Meeting of the Central Valley Flood Protection Board
May 19, 2017

Permit Staff Report

The City of Yuba City
Fifth Street Bridge Replacement, Yuba County

EXHIBIT NO. PROFILE

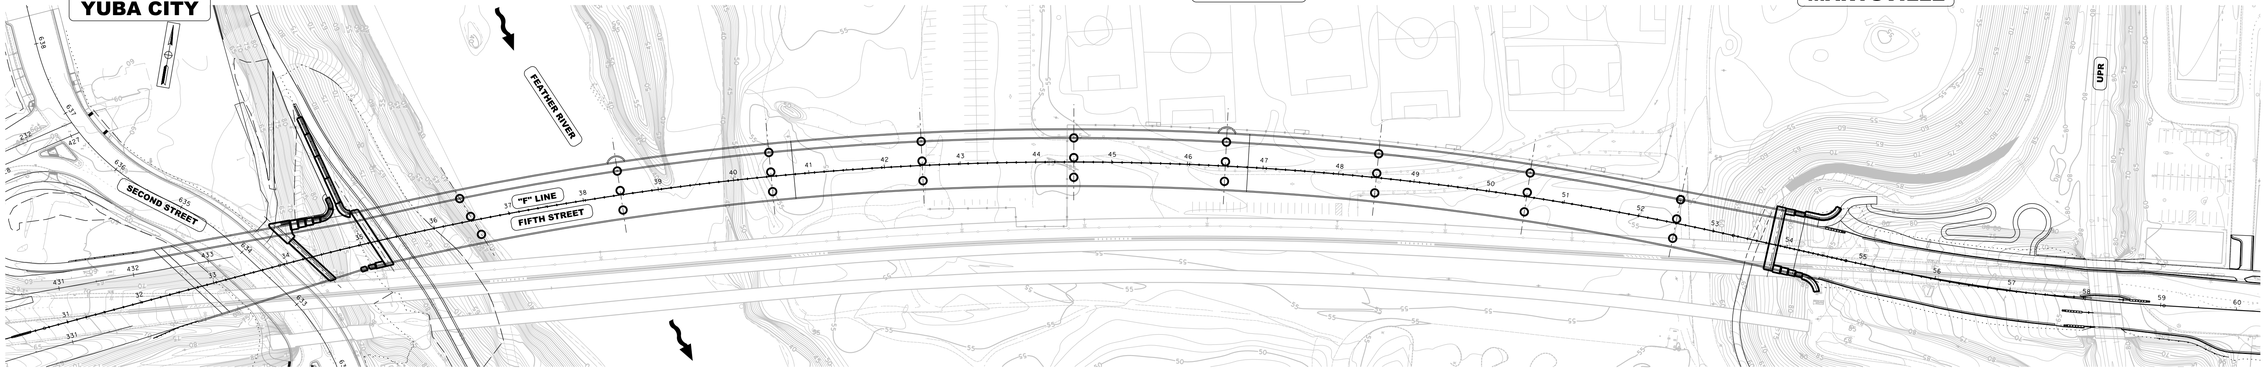
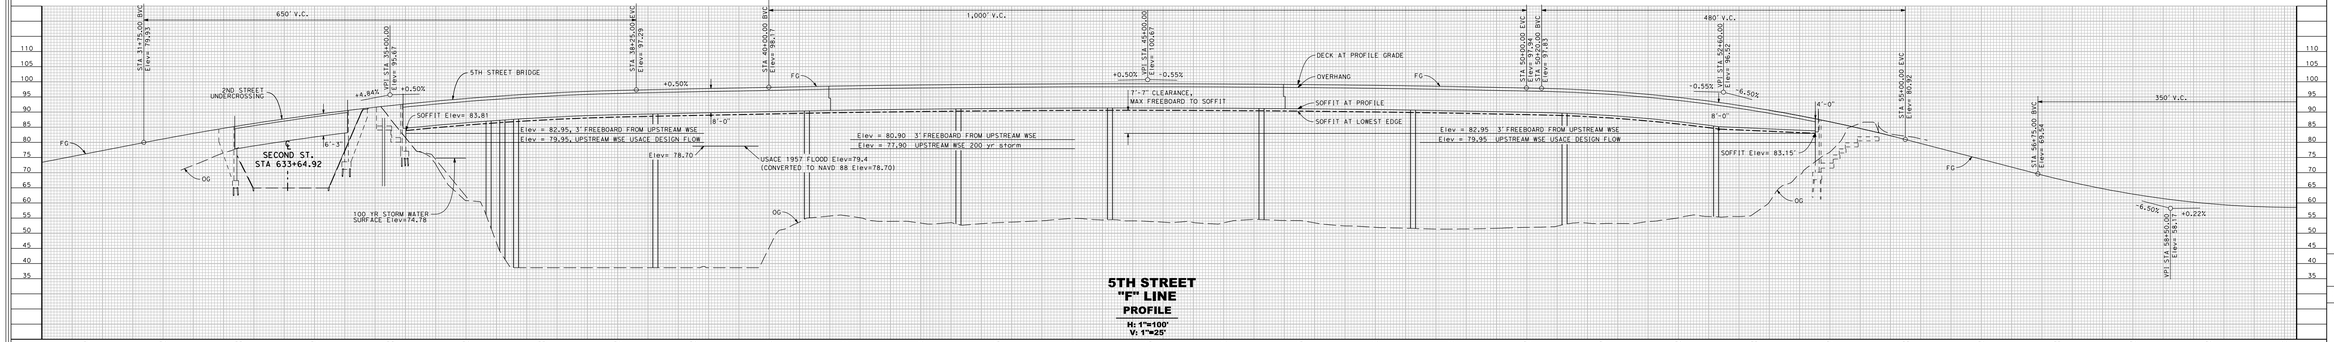
In order to achieve the required freeboard and avoid a variance request, the following bridge design modifications and soffit elevation clarifications have been made and are shown in the attached Profile Exhibit and hand calculations.

1. Cross slope adjustment – The cross slope of the wider upstream side of the bridge was changed to 1.5%, from 2%.

2. Freeboard at face of abutment – The previous clearance for freeboard was calculated at the End of Bridge, identified at Station "F" 53+85.00. Freeboard clearance is now calculated at Face of Abutment, identified at Station "F" 53+80.50.

Please find attached the Profile Exhibit, which shows the various water surface elevations for each design flood criteria and the associated freeboard required. A dashed line below the soffit

of the bridge represents the cross slope adjustment at the upstream edge of soffit. The soffit elevation, as shown in the hand calculations is identified at the face of each abutment, Abutment 1 in Yuba City and Abutment 11 in Marysville.

Bridge Condition	Freeboard (feet)		
	USACE Design Flow	200-Year	100-Year
Proposed	3.20	5.25	8.37
